U.S. ARMY CORPS  
OF ENGINEERS

VALUE ENGINEERING STUDY

**SOUTHEAST LOUISIANA  
FLOOD CONTROL,  
ORLEANS PARISH, LA**

**DRAFT REPORT**

DRAWING NO. 2

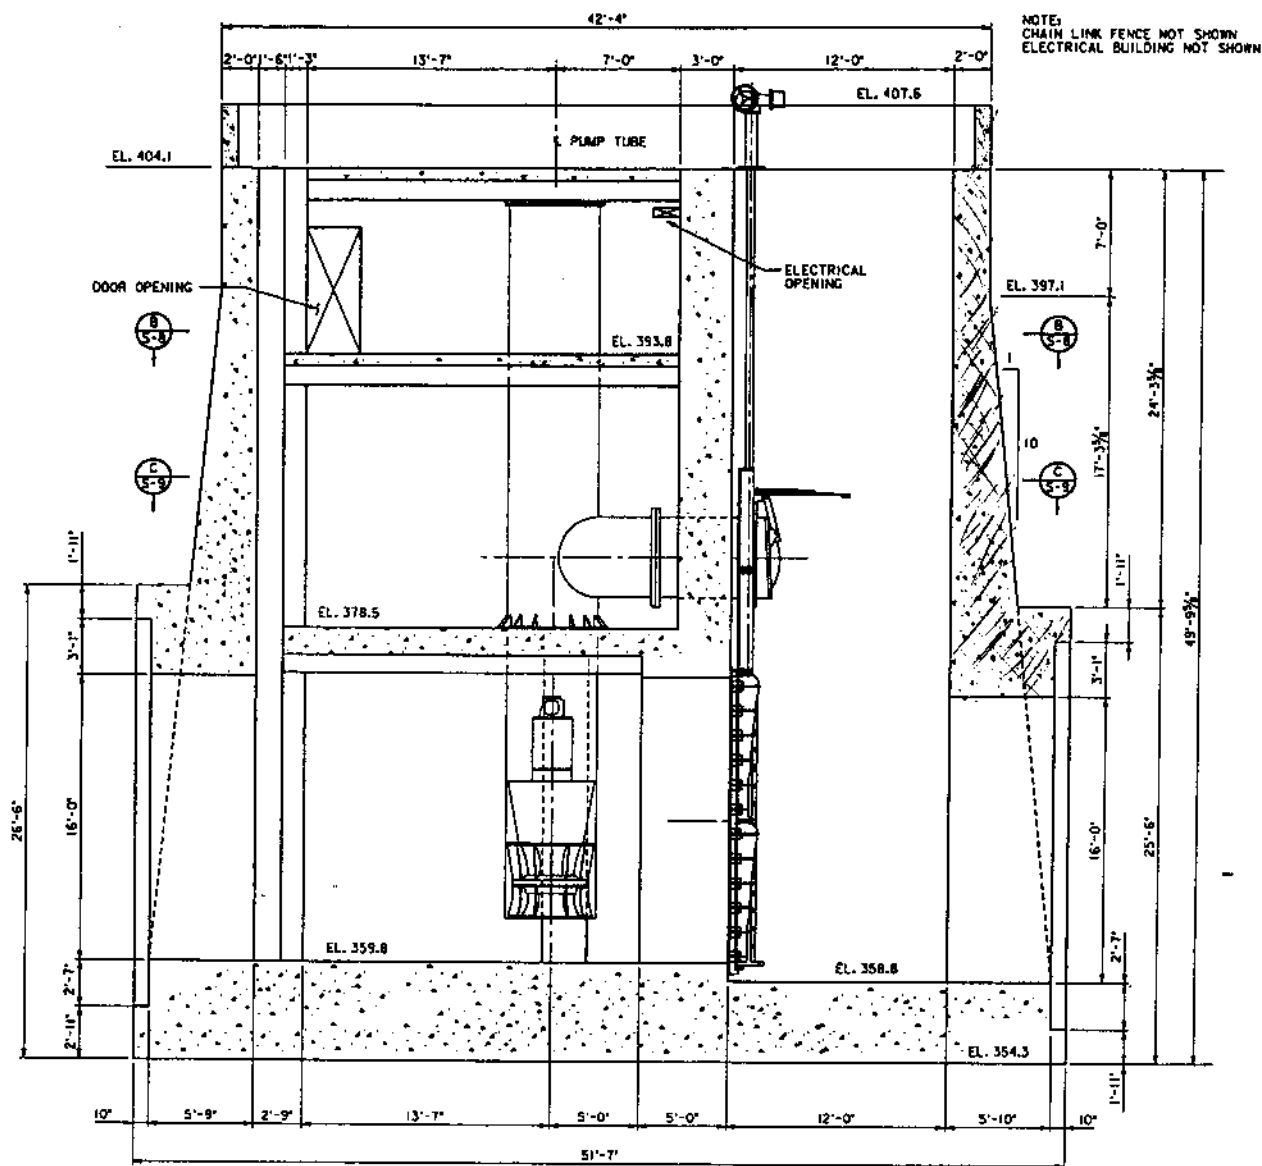
(See Drawing No. 2.) This proposal suggests employing submersible pumps. This proposal not only applies to the existing design adjacent to the existing pump station but also to Proposals C-1, C-2, and C-3.

DRAWING NO. 1

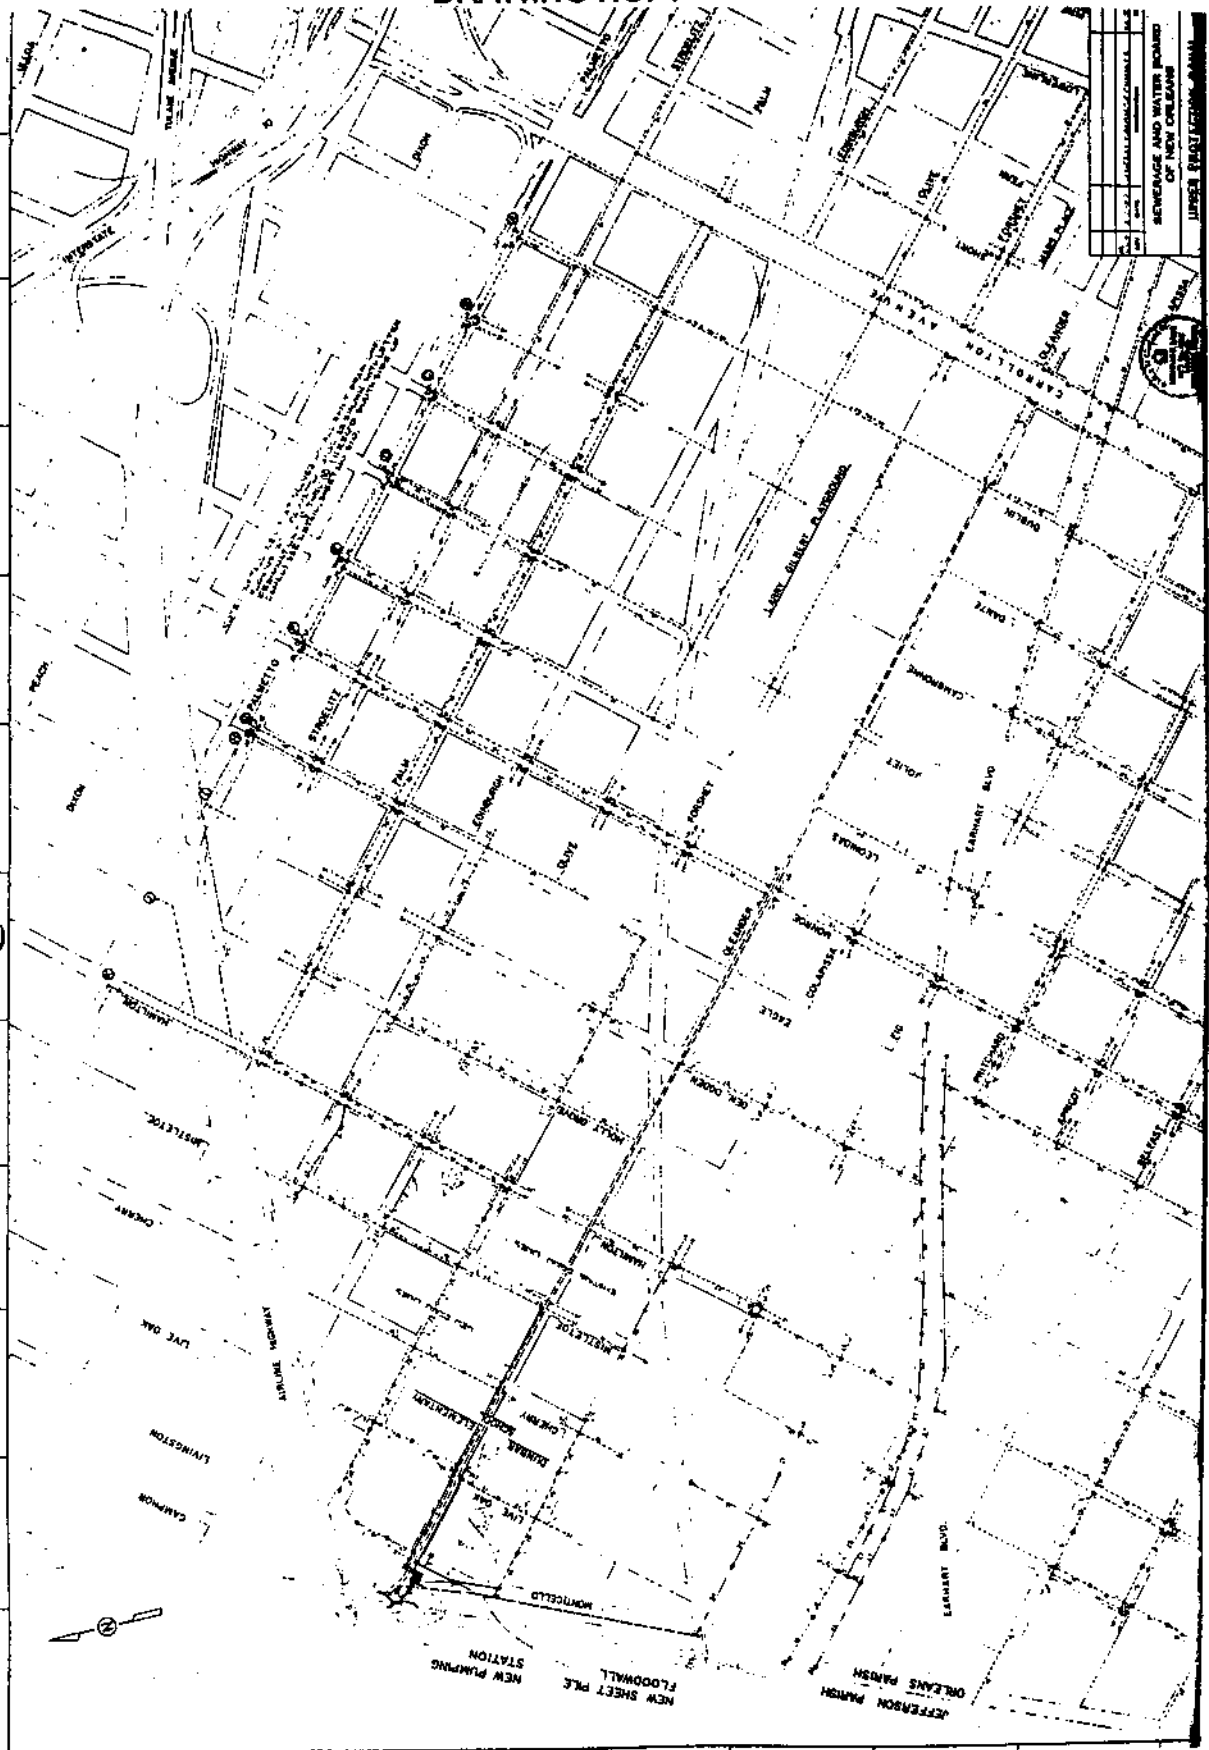
1. **Add Storm Sewer Connections East of Forshey to Capture Drainage** -- (See Drawing No. 1.) Comments were made that the Forshey alignment allows additional capture of storm drainage north of Forshey to the Palmetto Canal was not realized under the Oleander Plan. These connections can easily be made to the new railroad alignment at Dublin, Joliet, Leonidas and Monroe One block extensions will allow connection at Dante, Eagle and Holey Grove. Hookups can be made with one block extensions to the existing Oleander project at Hamilton (connections already exist at Dublin, Monroe, Holley Grove, and Cherry). The revised railroad alignment provides more versatility for capture of drainage north to Palmetto Canal.

DRAWING NO. 2

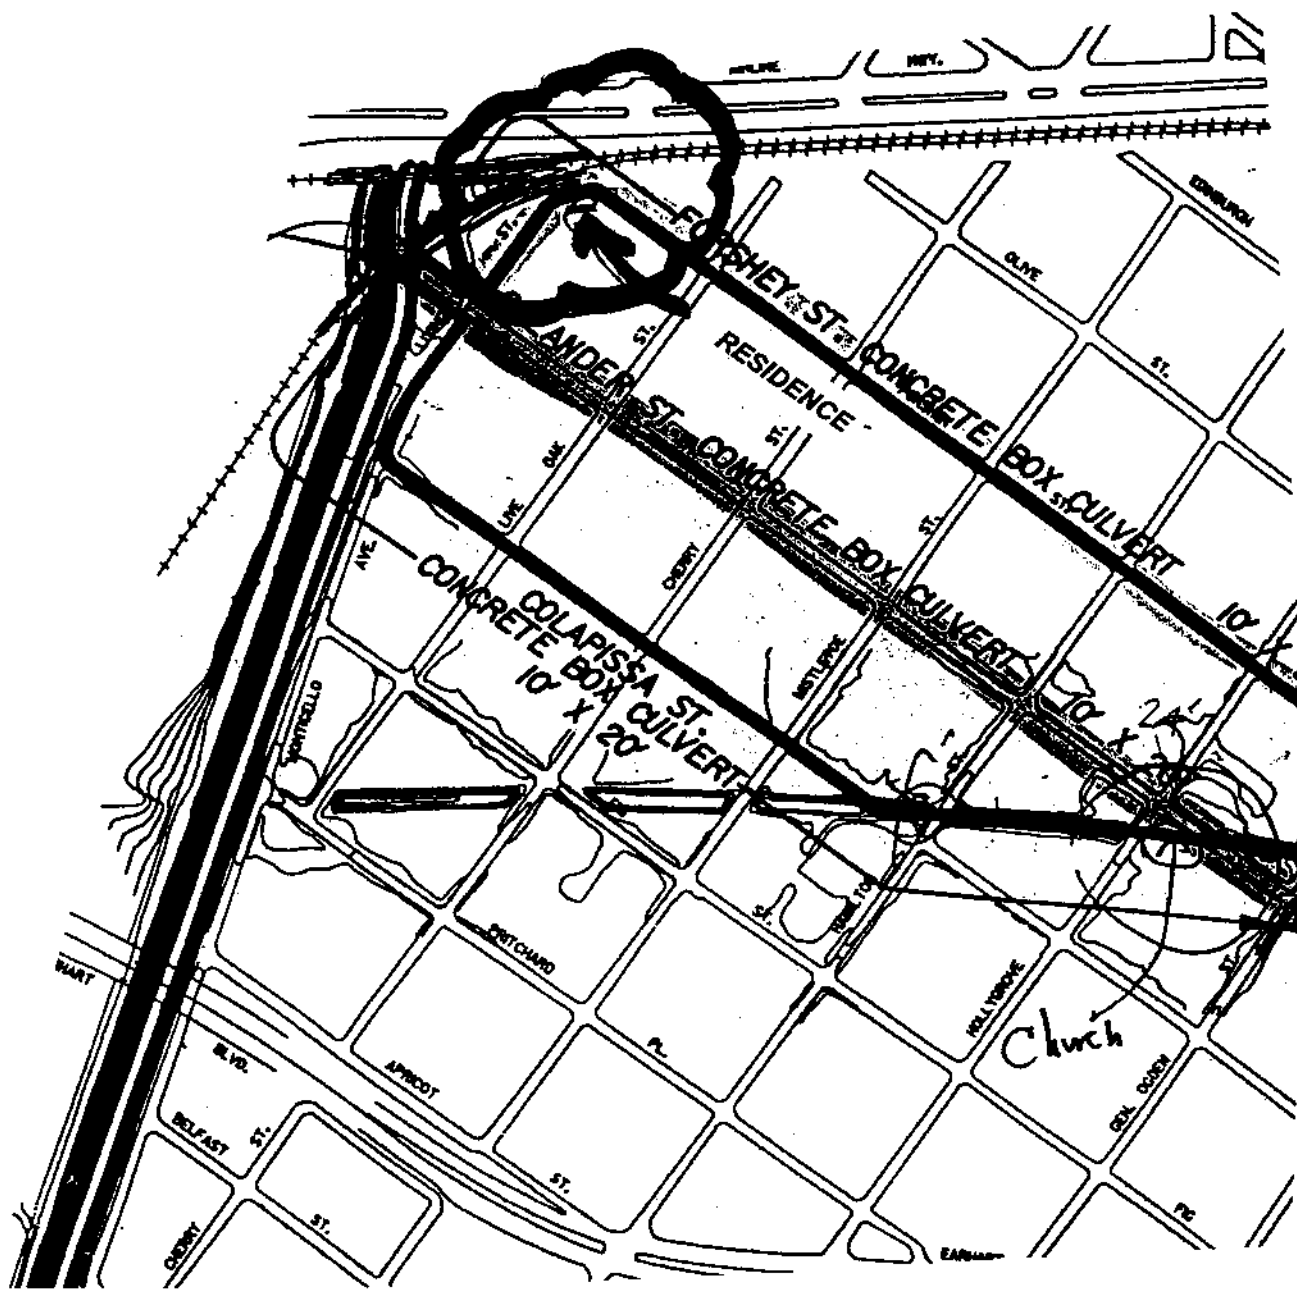
3. **Avoid buying House at Alternate No. 2 Plan at Forshey Street** -- (See Drawing No. 2.) Drawing No. 2 routes the 10' X 20' culvert westward along Forshey Street where it passes between the railroad and an existing residence. This commentary suggests that, if the proposal to optimize the culvert size results in a significantly smaller culvert/pipe, that an effort be made to fit the culvert such that it avoids the purchasing of the residence.
